EDU INTERNAL BATTERY REMOVAL***FALCON SERVICE BULLETIN***

FALCON 2000EX EASy
FALCON 2000LX
FALCON 2000LXS
FALCON 2000DX
FALCON 2000S

No 507**December 18, 2023****MANDATORY****ATA 46****INFORMATION SYSTEMS****ELECTRONIC FLIGHT BAG SYSTEM****EDU INTERNAL BATTERY REMOVAL**© 2023 - Dassault AviationAll rights reserved.

REASON: Modification of BIOS zip file CRC32 calculation.

Figure 1: EXTERNAL REMOVABLE BATTERY REPLACEMENT

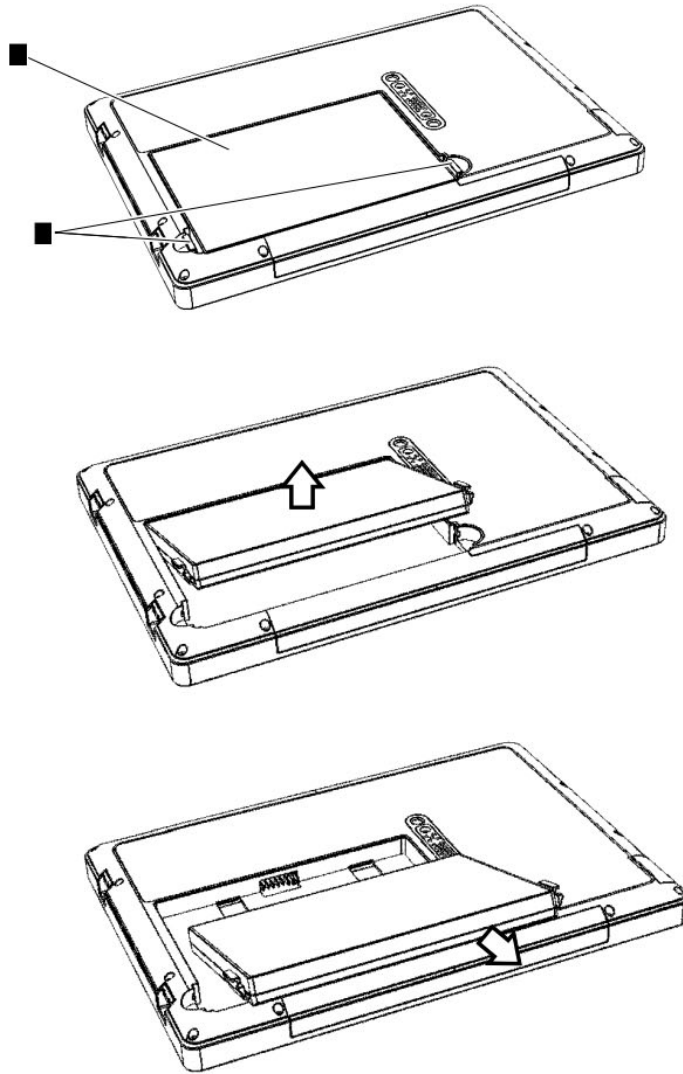
- (1) Obey the general maintenance and safety precautions ([TASK 20-00-00-910-801](#)).
- (2) Check the external removable battery for integrity (no swelling). If swelling is noticed, replace the battery :
 - Press the two clips (1-fig. 1) to unlock the battery (2-fig. 1).

- Remove the battery (2-fig. 1).
 - Install a new battery (2-fig. 1) in position.
 - Make sure that the clips (1-fig. 1) are engaged.
- (3) Get a software that can calculate CRC32 checksum (for example "7-zip File Manager").

Figure 2: BIOS CHECKSUM CALCULATION

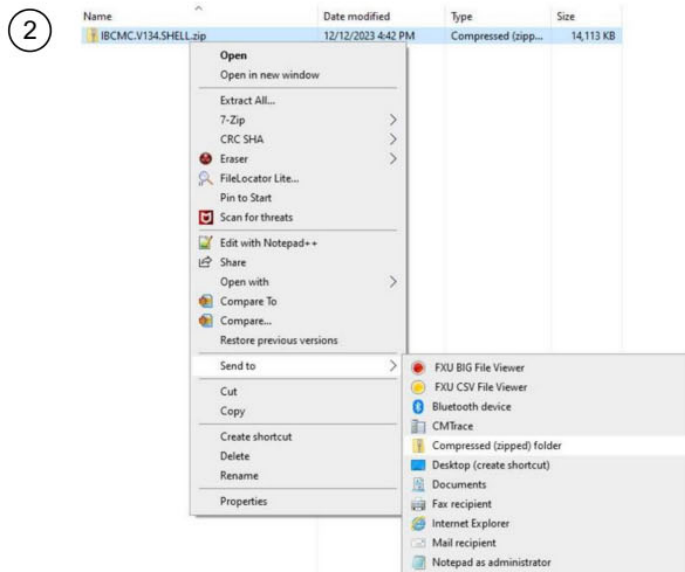
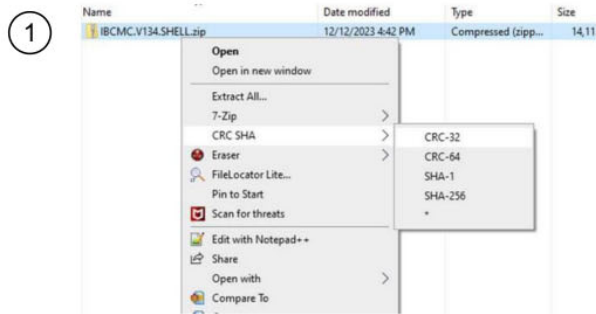
- (3) Download the CMA-1310 AMI BIOS V134 (File name: IBCMC.V134.SHELL.zip) software from the Falcon Portal to a USB key (Refer to [3.B.](#)).
- (4) Proceed to BIOS zip file CRC32 calculation (for example with "7-zip" previously got) ([fig. 2](#)) as follows:

- If the "7-Zip / CRC SHA" functionality is available, perform the following steps:
 - right click on the ".zip" file, the "CRC SHA" menu, and then the "CRC-32" option (1-fig. 2),

- check that the "CRC-32" value is "560244EA".
 - If the "7-Zip / CRC SHA" functionality is not available, perform the following steps:
 - right click on the ".zip" file, then select "Send to a compressed folder" option (2-fig. 2),

- select "Yes" to create the .zip file on the desktop,
 - right click to open the .zip file on the desktop,
 - if necessary, right click in the explorer header to activate the "CRC-32" option (3-fig. 2),

- check that the "CRC-32" value is "560244EA".
- (5) Remove the EDU from its support.
